RE: Mod 2020/0146 - 13 A Ocean Road, Palm Beach
Subject: Response to neighbour objections

We act on behalf of the applicant, Mrs Michele Matthews. We have reviewed the objection letters sent to Council with regards to the Section 4.55 proposed modifications to the approved DA 2019/0619 and make the following submission in reply.

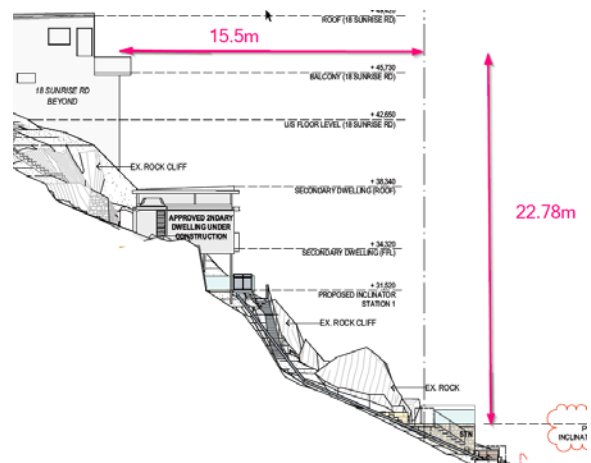
Acoustic requirements

We understand Mr Cooke's requests and confirm we have no objection to the retention of the condition 9 of the DA approval which addresses acoustic attenuation requirements for the approved inclinator.

We confirm that the inclinator rail is set back 2.5m from the boundary and that the carriage will not encroach closer than 2m from the boundary.
